Attachment G
Exceptions to Design Standards

Fact Sheet Exceptions to Mandatory Design Standards

LAUREN PROCTOR, Registered Civil Engineer
CH2M HILL

MANDATORY EXCEPTION NO. 3A
SHOULDER WIDTH VARIES 3.2 FEET TO 10 FEET

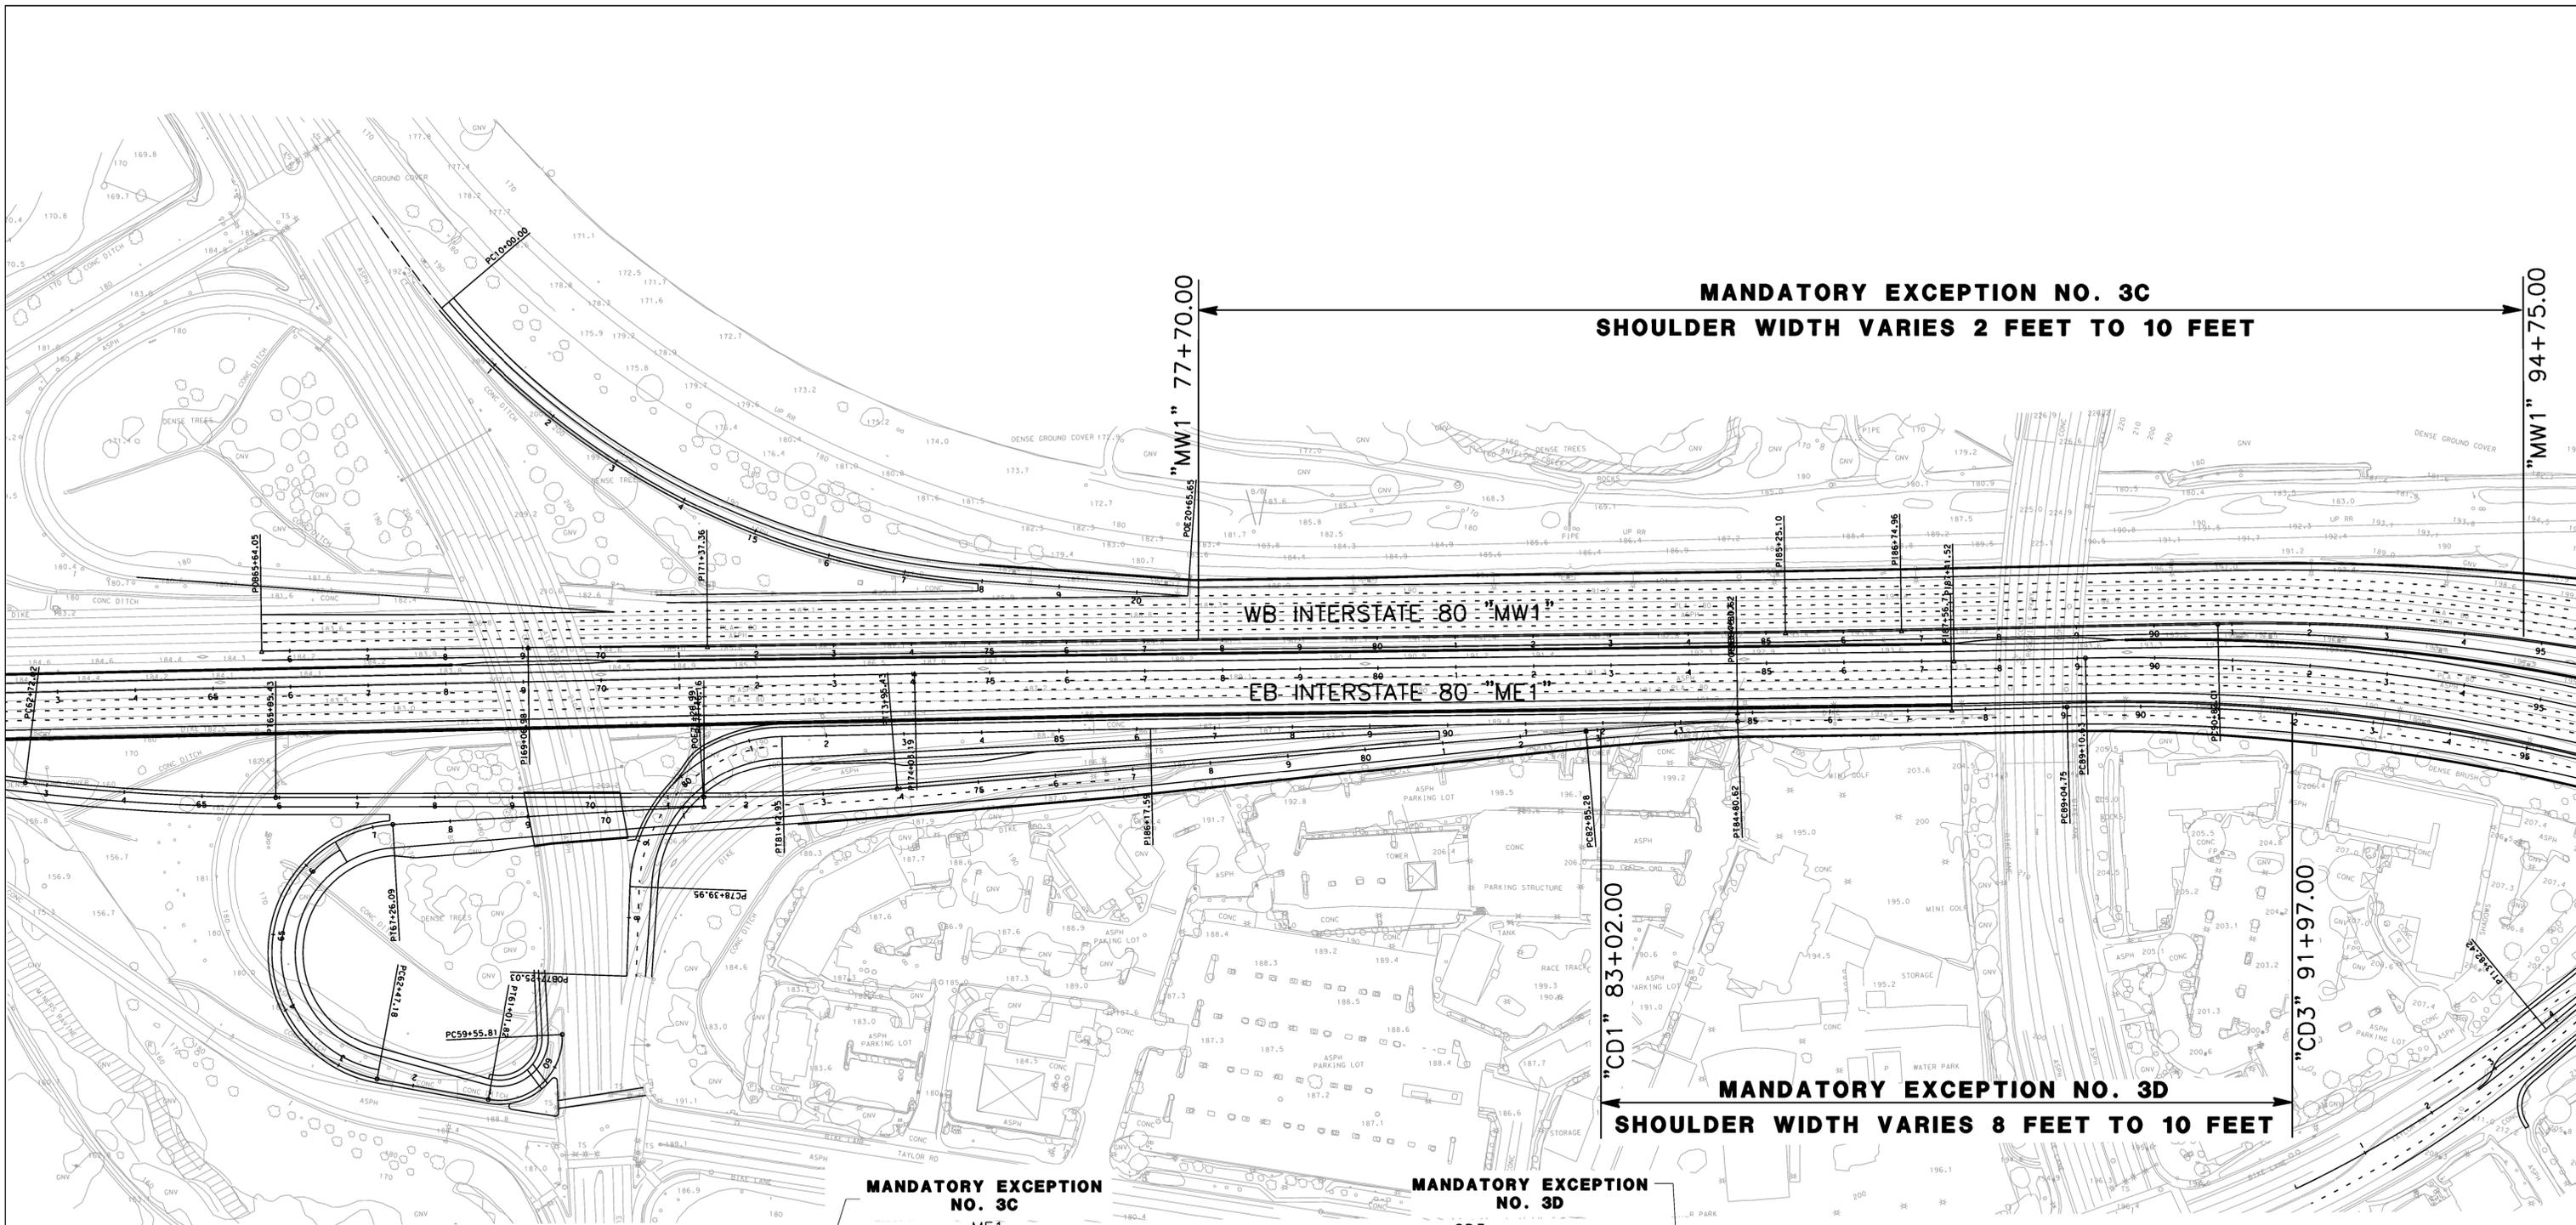
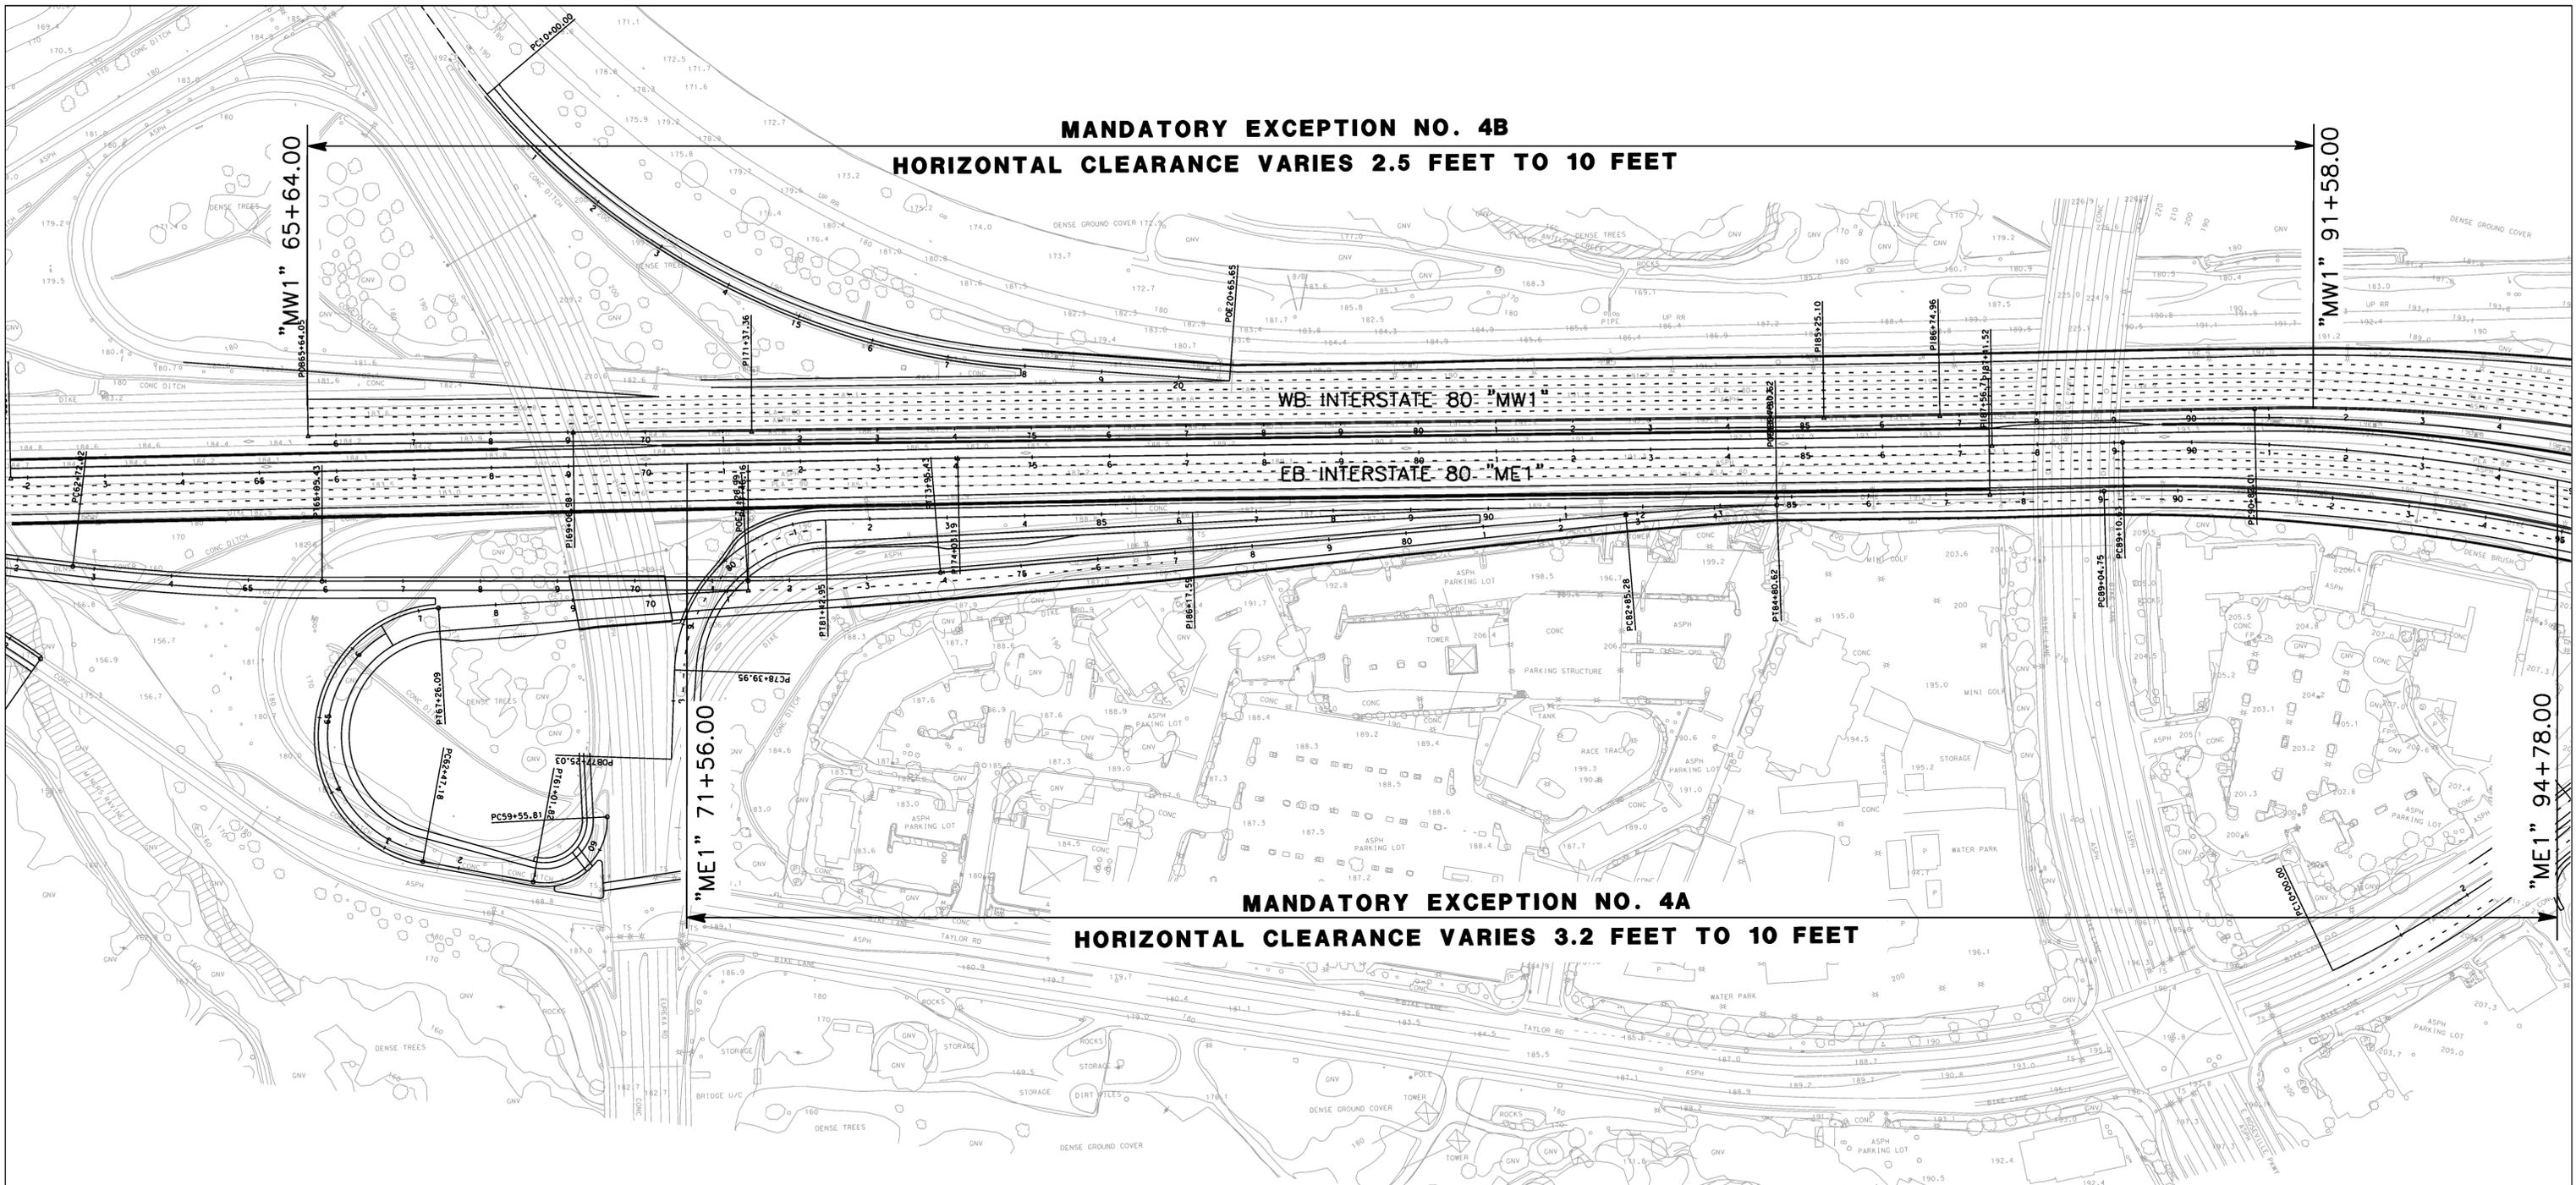
Location A: The width of the left shoulder of eastbound I-80 will vary from 3.2 feet to 10 feet between station “ME1” 71+56 and station “ME1” 94+78, a total length of 2,322 feet. (See Attachment 10)

Location B: The width of the left shoulder of westbound I-80 will vary from 2.5 feet to 10 feet between station “MW1” 65+64 and station “MW1” 91+58, a total length of 2,594 feet. (See Attachment 10)

MANDATORY EXCEPTION NO. 3B
SHOULDER WIDTH VARIES 2.5 FEET TO 10 FEET

The reason for this design exception is due to the location being immediately adjacent and parallel to UPRR on the north side and several businesses on the south side of I-80. The existing support piers and south abutment of the Roseville Parkway Overcrossing also restrict widening.

ATTACHMENT 12

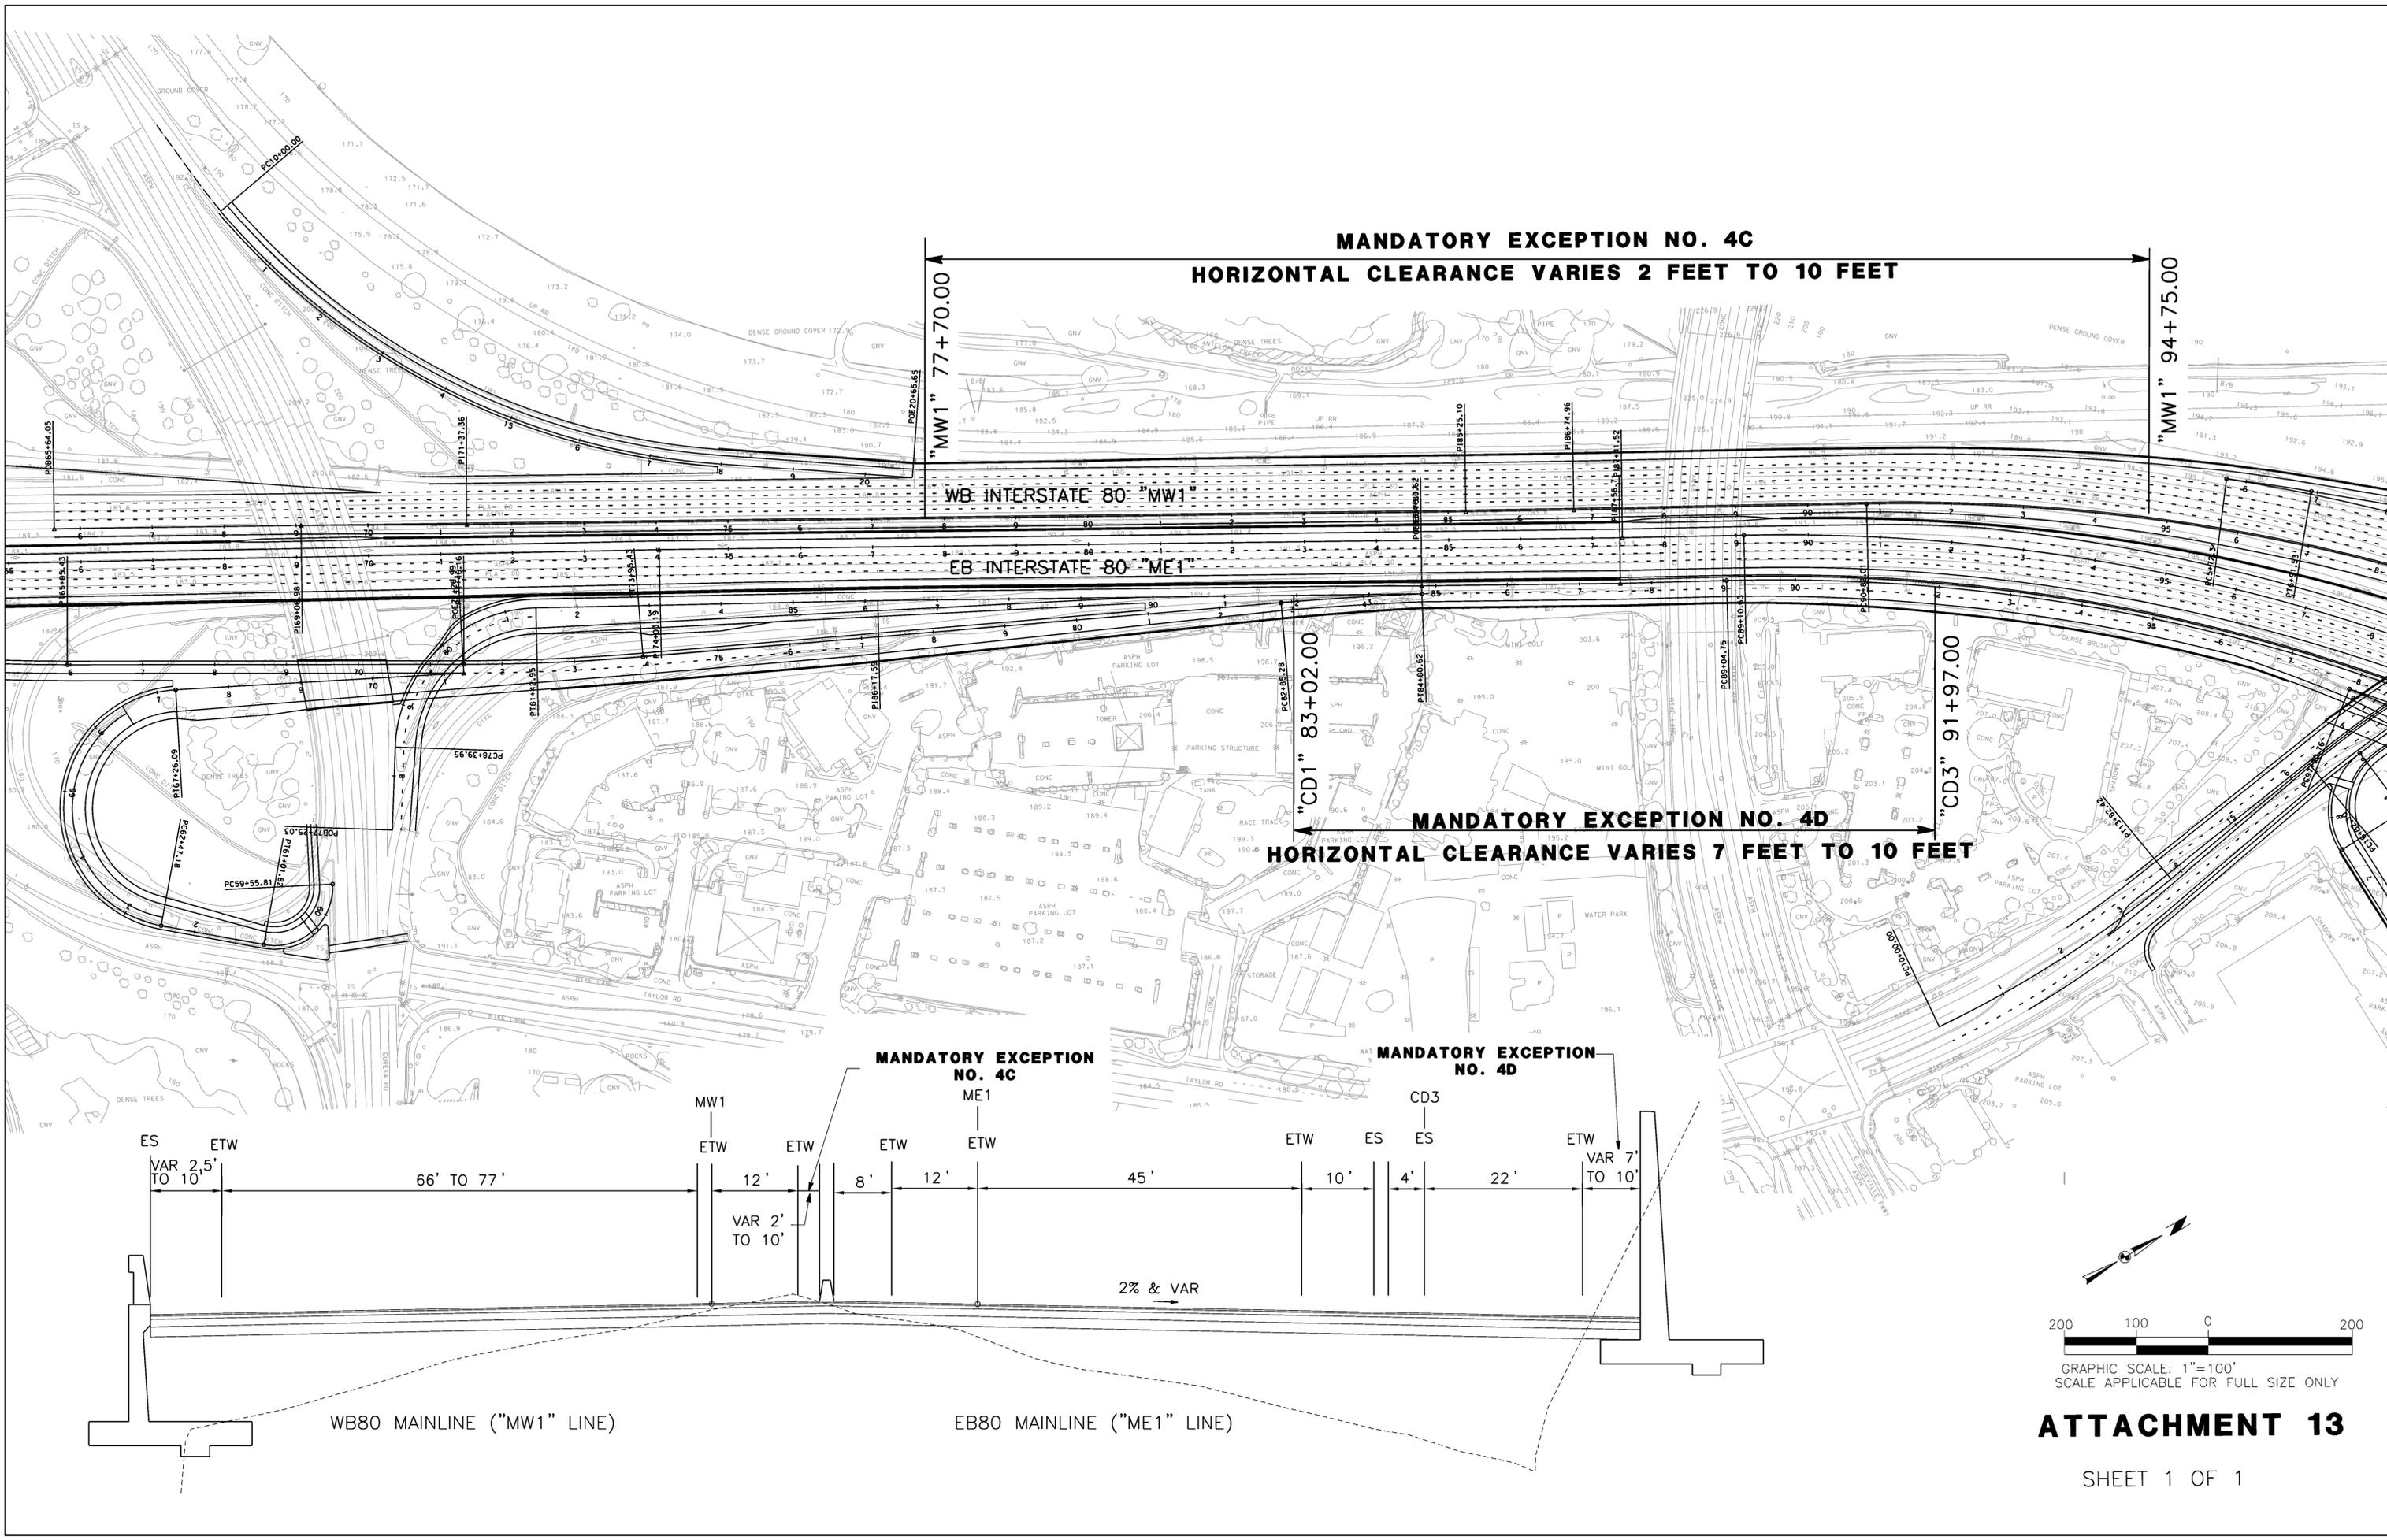
Location A: The horizontal clearance to inside shoulder barrier of eastbound I-80 will vary from 3.2 feet to 10 feet between station “ME1” 71+56 and station “ME1” 94+78, a total length of 2,322 feet. (See Attachment 12)

Location B: The horizontal clearance to inside shoulder barrier on westbound I-80 will vary from 2.5 feet to 10 feet between station “MW1” 65+64 and station “MW1” 91+58, a total length of 2,594 feet. (See Attachment 12)

MANDATORY EXCEPTION NO. 4B
HORIZONTAL CLEARANCE VARIES 2.5 FEET TO 10 FEET

MANDATORY EXCEPTION NO. 4A
HORIZONTAL CLEARANCE VARIES 3.2 FEET TO 10 FEET

The reason for this design exception is due to the location being immediately adjacent and parallel to UPRR on the north side and several businesses on the south side of I-80. The existing support piers and south abutment of the Roseville Parkway Overcrossing also restrict widening.
